PWA Doc No. Vt-1092-F-89

MODIFIED DETAILS AND NOTES FOR USE WITH STANDARD SHEET S.1.B. 24
BRIDGE No. 89
FAYSTON

PART TRANSVERSE SECTION OF SLAB
Showing transverse steel as modified

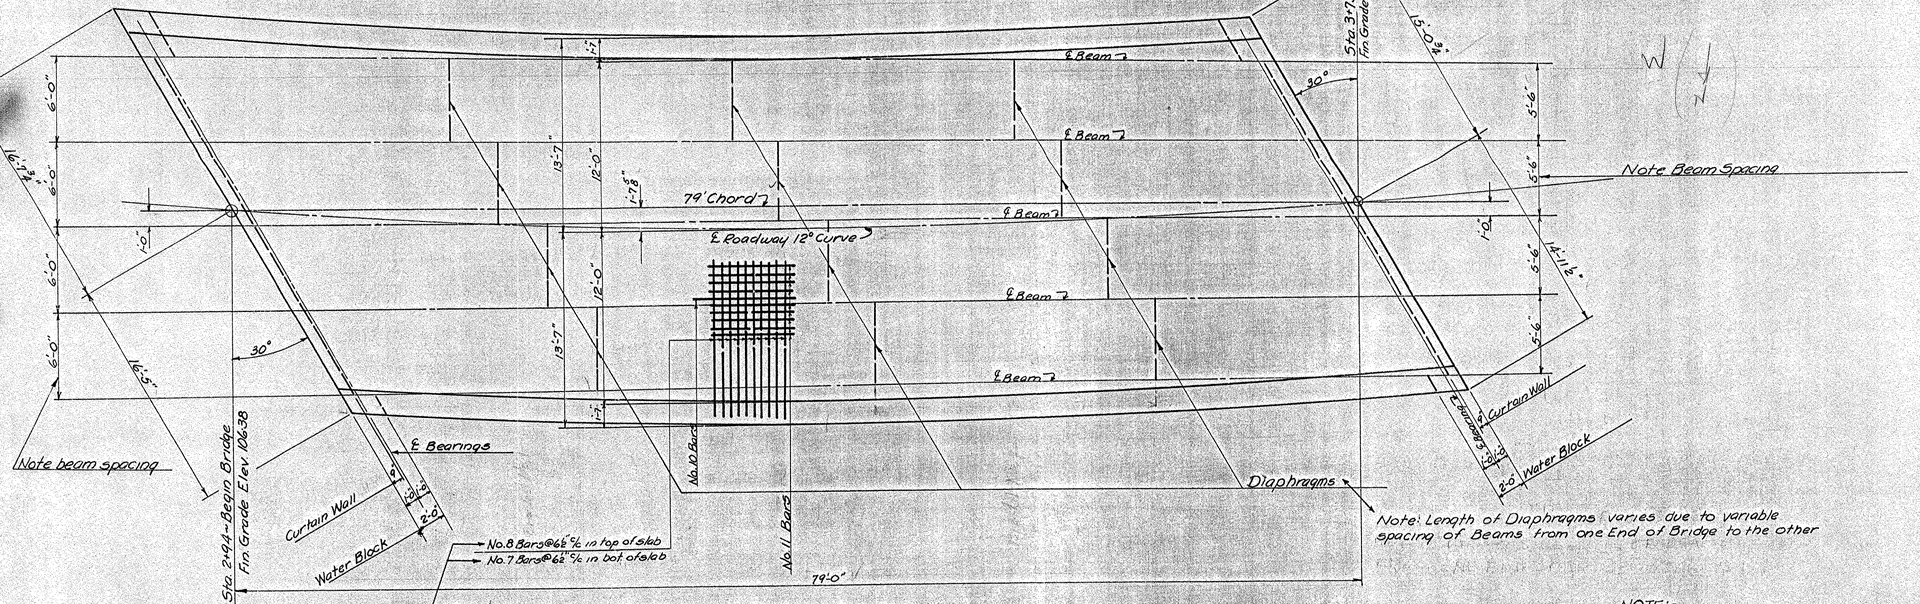
Note change in Transverse Slab Steel from that shown on Standard Sheet S.1.B. 24
Bars No. 7 and No. 8 ~ 146 Reqd.
Bar No. 9 ~ None Reqd.

NOTE:- This sheet to be used with Standard Sheet S.1.B. 24. All details and notes on this sheet which differ from those shown on S.1.B. 24 will be used in place of those shown on S.1.B. 24.
